# Access Compliance Report

## Public Rights-of-Way

Intersection ID: 5192	Main Street: CARRONBRIDGE_LN	Cross Street: SOUTHMINSTER_LN	Location:	N
ADA ID: 71AF28AEB2B9	Ramp Type: BlendTrans1	Initial Pass/Fail: Pass	Overall Compliance: No	Severity Score: 7.75

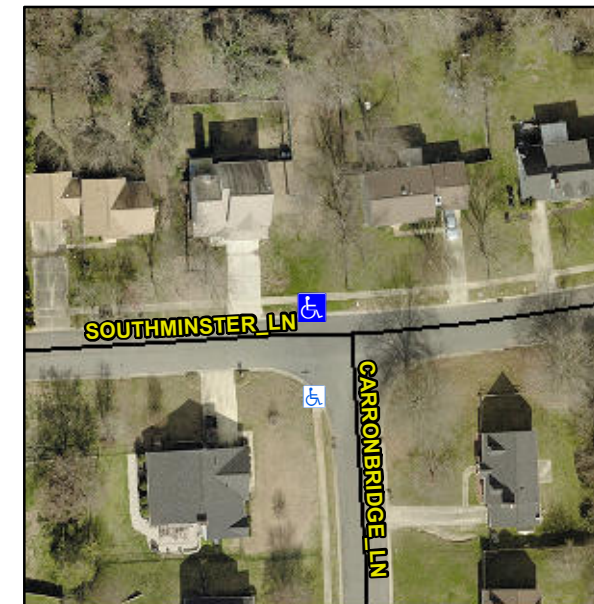
**Not Found, R304.5.3, R304.2.1, R302.7.2**

Compliance	Description	Data	Compliance	Description	Data
N/A	Ramp Length (in)	24.0	Yes	BlendTrans Slope (%)	5.0
Yes	Ramp Width (in)	48.0	No	BlendTrans XSlope (%)	3.1
N/A	Flare Type LT	Sloped	N/A	Flare Type RT	Sloped
Yes	Flare Slope LT (%)	5.6	Yes	Flare Slope RT (%)	0.0
N/A	Flare Traversable LT?	Yes	N/A	Flare Traversable RT?	Yes
No	Landing Length (in)	46.0	Yes	DWS Provided?	Yes
Yes	Landing Width (in)	48.0	Yes	DWS Contrast?	Yes
Yes	Landing Slope (%)	1.9	Yes	DWS Length (in)	24.0
No	Landing X Slope (%)	4.2	Yes	DWS Full Width?	Yes
N/A	Landing Curb? (Y/N)	No	Yes	DWS Offset (in)	0.0
N/A	Shared Landing?	No			
Yes	Gutter Ponding?	No	Yes	Gutter Slope (%)	4.7
No	Gutter Lip Ht (in)	0.5	Yes	Gutter X Slope (%)	2.6
N/A	Painted X Walk1?	No	N/A	Painted X Walk2?	N/A
	X Walk 1 Direction	To S		X Walk 2 Direction	N/A
	X Walk 1 Width (in)	N/A		X Walk 2 Width (in)	N/A
	X Walk 1 Slope (%)	1.9		X Walk 2 Slope (%)	N/A
	X Walk 1 X Slope (%)	2.7		X Walk 2 X Slope (%)	N/A

N/A	Ramp inside XWalk1?	N/A	N/A	Ramp inside XWalk2?	N/A
	Road Slope (%)	2.7		Clear Space?	Yes
	Road X Slope (%)	1.9	N/A	Clear Space to XWalk (in)	N/A
Yes	Any Obstructions?	No	Yes	Storm Grate/Utility Hazard?	No
	Obstruction Type			Storm Grate/Utility Type	
			N/A		N/A
			Yes	Surface Condition? (G/P)	Good
			No	Curb Slope (%)	11.5

**Remove & Replace Curb Ramp With Two New Directional Ramps or Equivalent.**
